Part 21 (PAR)

NOTICE OF DEVIATION REGARDING K-LINE CIRCUIT BREAKER SECONDARY CLOSE LATCH

Subject: Amendment to Previously Submitted Notification: 10CFR Part 21 Notification of Deviation
re. K-Line Circuit Breaker Secondary Close Latch

Figure 2 – Secondary Close Latch

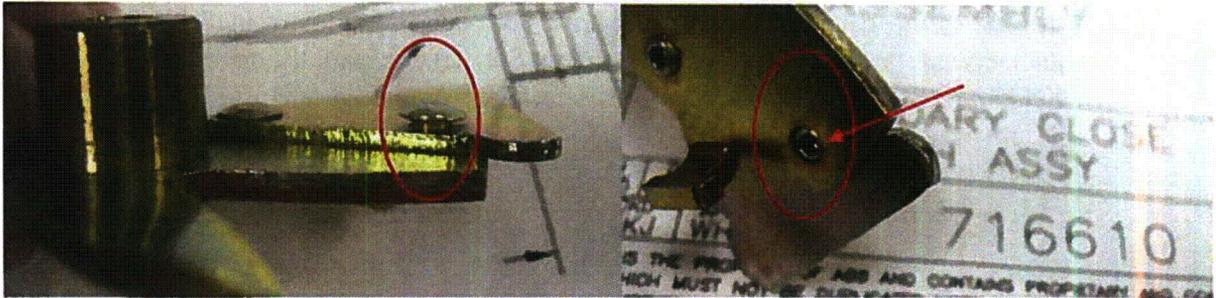
During outgoing inspection a breaker failed to close during the operational phase of the testing procedure. The inspector found that the cam attached to the top of the secondary close latch, 716610K01, was not properly riveted in place. The head of the rivet was not pushed down flush against the side of the cam. Since the rivet was not seated properly, the other end of the rivet did not project through the other side of the latch and therefore the bradded end of the rivet was not deformed in a manner to sufficiently apply the required holding force to keep the cam in its proper and secure operating position. (see Figure 2)

6. Corrective actions include:
 - a. Perform 100% inspection all part number 716610K01 secondary close latches in inventory to identify the nonconforming latches. (Action complete)
 - b. Trained inspectors and breaker assemblers on identifying this condition (Action Complete)
 - c. Contact primary vendor to investigate cause and correct on future orders. (Action Complete)
 - d. Verified that this is the only assembly with bradding that this vendor provides. (Action complete)
 - e. Notification of the potential existence of this deviation to affected customers (Action to be completed by 18 August 2014)
